City of
GREENFIELD, MASSACHUSETTS

MEMO

Re: Greenfield Library Overview (Leavitt Hovey House)

Picture 6

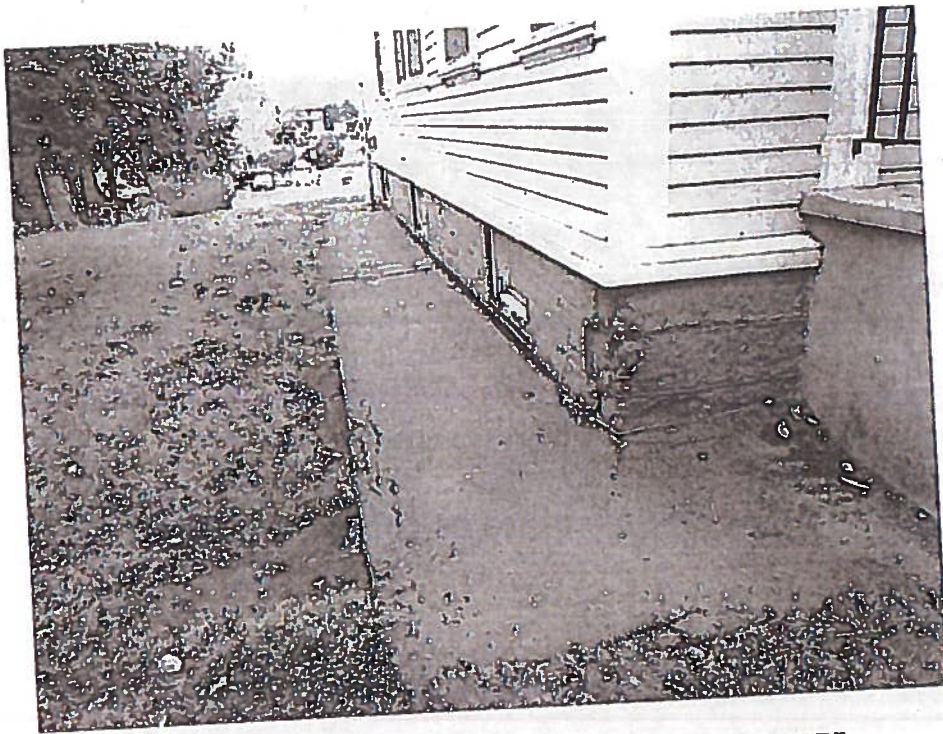
The east side of the tree has its root system disrupted by a sidewalk and the driveway of the Greenfield Fire Station

Picture 7

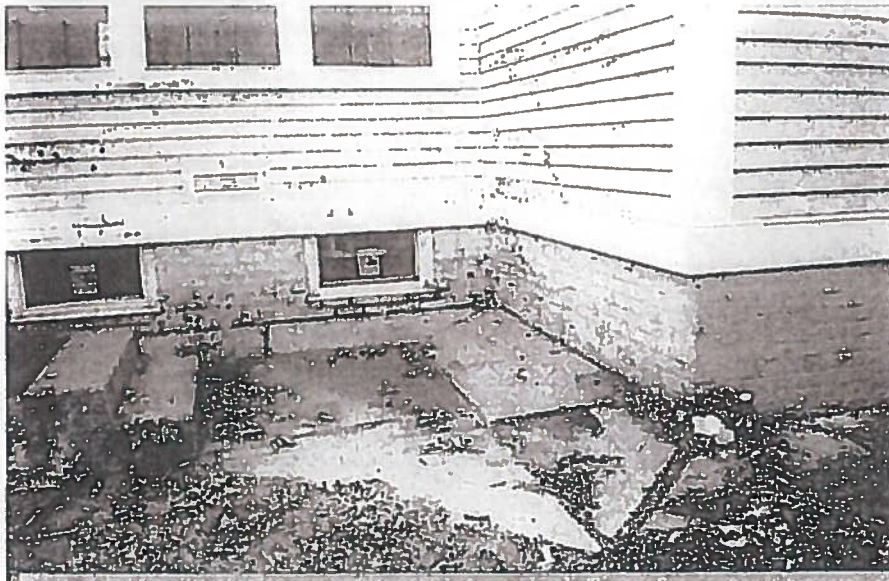
Pooling Rainwater from Roof, Note Damage to Foundation Stone in Proximity to Pool

Picture 9

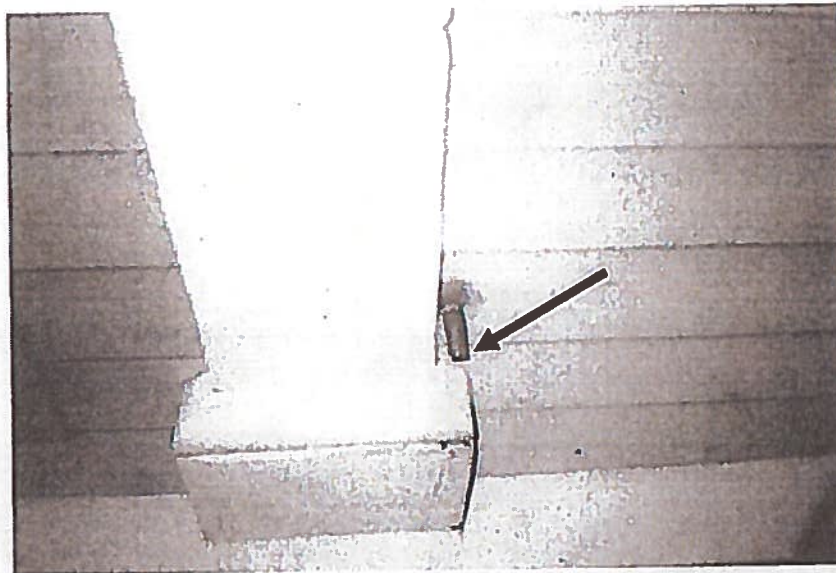
Chimney-Like Structures on the Roof Of the 1797 Wing
